In the Drawings

REMARKS

Figure 4
SYSTEM AND METHOD FOR UPCONVERTING
STACKED INTERMEDIATE FREQUENCY CARRIERS

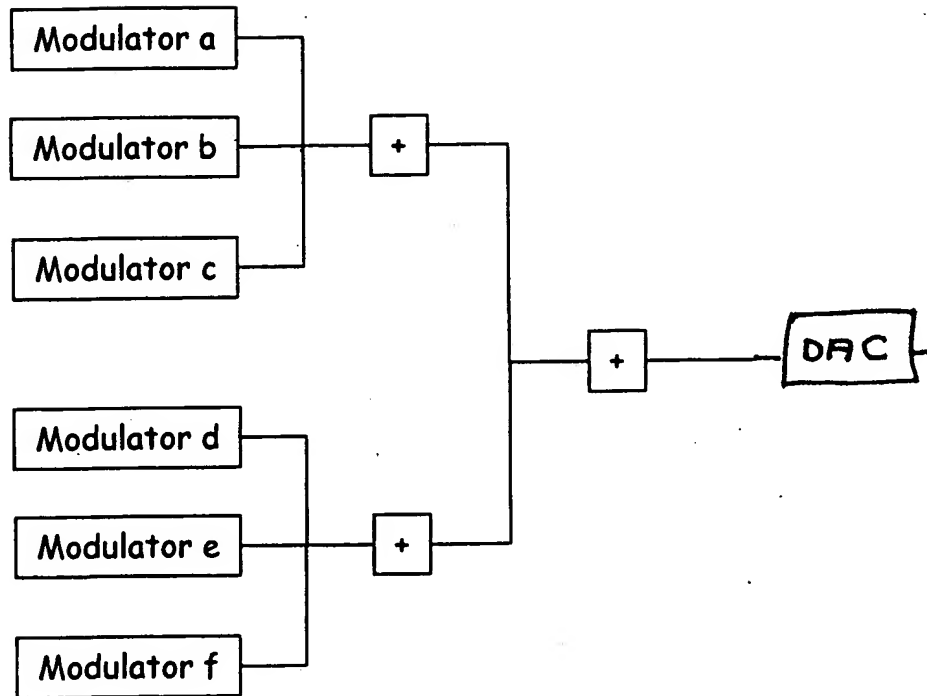
FIG. 4 has been amended to add a *DAC* device after the last summer (+) circuit.

The drawing figures have been corrected in accordance with the Examiner's suggestions. Specifically, FIG. 4 has been amended to add a DAC (digital-to-analog converter) device after the last summer (+) circuit. FIG. 4 is now more consistent with claim 12, which describes a first number of summer circuits (3) and a second number of DAC devices (1), the second number being greater than the first number. The change to FIG. 4 is consistent with description, in which it is explained that the outputs of the summer devices are provided to the DAC devices. See for example the second half of paragraph [0006]. No new matter has been introduced. Approval of the corrections is respectfully requested.
